# CITY OF SACRAMENTO PLANNING COMMISSION 1231 "I" STREET, SUITE 200, SACRAMENTO, CA 95814

- A. Negative Declaration;
- B. Tentative Map to divide 0.88 + acres into six single family lots in the Multiple Family Review (R-2A-R) zone;
- C. Plan Review for six 1,900 + square foot single family homes;
- D. Variance to create six lots less than 52 feet in width; and
- E. Subdivision Modification to create six lots less than 52 feet in width on 0.88 + acres in the Multiple Family Residential Review (R-2A-R) zone.

LOCATION: Between 57th and 58th Streets, 110 feet north of Broadway

FRONT ELEVATION #2

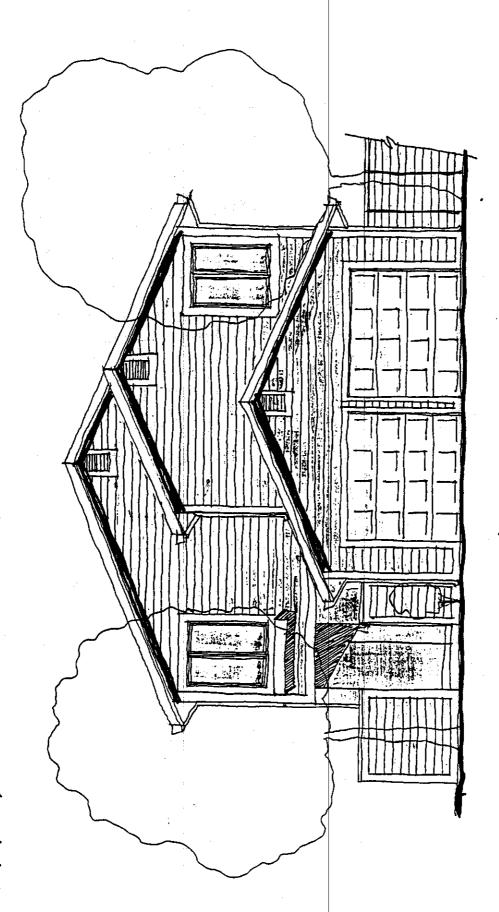
The applicant has proposed two story structures containing approximately 1,900 square feet on these parcels. The proposed exterior materials are horizontal lapped siding and wood shingles. Staff suggests the design of the buildings be reviewed and approved by Design Review Staff. Staff suggests modifications including having the main entrance of the house visible from the streets, and enhanced window treatments. Staff also suggests reducing the prominence of the garage by decreasing its width. The applicant shall provided all four elevations of each unit for the Design Review Staff review. There should be some variation of the front elevations for the three units adjacent on each street.

- 1. The applicant shall submit revised elevations to City Design Review Staff for review and approval prior to the issuance of Building Permits. These revised elevations shall be for all six buildings, all four elevations. The modifications should include the main entrance visible from the street, enhanced window treatment, and reducing the prominence of the garage. The elevations of the six units shall vary subject to review and approval of the Design Review Staff.
